Access Compliance Report

Public Rights-of-Way

Intersection ID: N/A	Main Street: SPRINGWOOD_ESTATE_DR	Cross Street: BELVEDERE_CASTLE_DR	Location: NW
ADA ID: E02C0E638283	Ramp Type: BlendTrans1	Initial Pass/Fail: Fail	Overall Compliance: No
Severity Score: 10			
Codes/Mitigation Info/Possible Solution		Field Measurements/Component Compliance

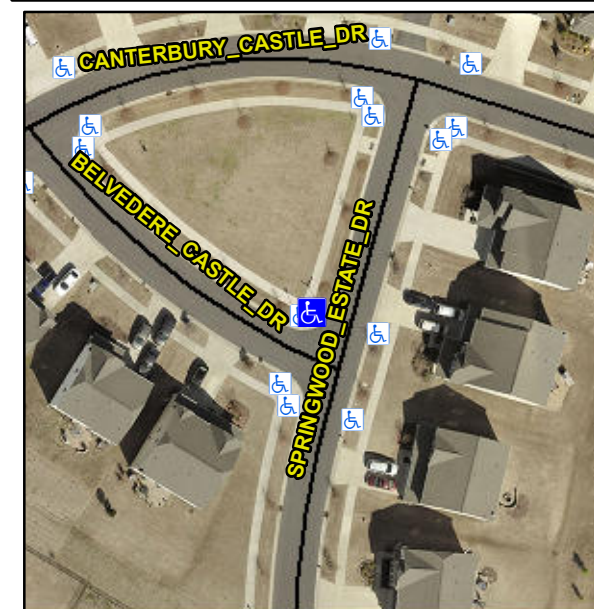
Not Found, R304.5.1, R304.5.3

Compliance	Description	Data	Compliance	Description	Data
N/A	Ramp Length (in)	75.0	Yes	BlendTrans Slope (%)	1.1
No	Ramp Width (in)	46.0	No	BlendTrans XSlope (%)	3.3
N/A	Flare Type LT	N/A	N/A	Flare Type RT	N/A
N/A	Flare Slope LT (%)	N/A	N/A	Flare Slope RT (%)	N/A
N/A	Flare Traversable LT?	N/A	N/A	Flare Traversable RT?	N/A
N/A	Landing Length (in)	N/A	N/A	DWS Provided?	N/A
N/A	Landing Width (in)	N/A	N/A	DWS Contrast?	N/A
N/A	Landing Slope (%)	N/A	N/A	DWS Length (in)	N/A
N/A	Landing X Slope (%)	N/A	N/A	DWS Full Width?	N/A
N/A	Landing Curb? (Y/N)	N/A	N/A	DWS Offset (in)	N/A
N/A	Shared Landing?	N/A			
N/A	Gutter Ponding?	N/A	N/A	Gutter Slope (%)	N/A
N/A	Gutter Lip Ht (in)	N/A	N/A	Gutter X Slope (%)	N/A
N/A	Painted X Walk1?	No	N/A	Painted X Walk2?	N/A
	X Walk 1 Direction	To SE		X Walk 2 Direction	N/A
	X Walk 1 Width (in)	N/A		X Walk 2 Width (in)	N/A
	X Walk 1 Slope (%)	3.6		X Walk 2 Slope (%)	N/A
	X Walk 1 X Slope (%)	2.6		X Walk 2 X Slope (%)	N/A

N/A	Ramp inside XWalk1?	N/A	N/A	Ramp inside XWalk2?	N/A
	Road Slope (%)	2.6		Clear Space?	N/A
	Road X Slope (%)	3.6	N/A	Clear Space to XWalk (in)	N/A
N/A	Any Obstructions?	N/A	N/A	Storm Grate/Utility Hazard?	N/A
	Obstruction Type			Storm Grate/Utility Type	
		N/A			N/A
			Yes	Surface Condition? (G/P)	Good
			No	Curb Slope (%)	6.6

Remove & Replace Curb Ramp With Two New Directional Ramps or Equivalent.
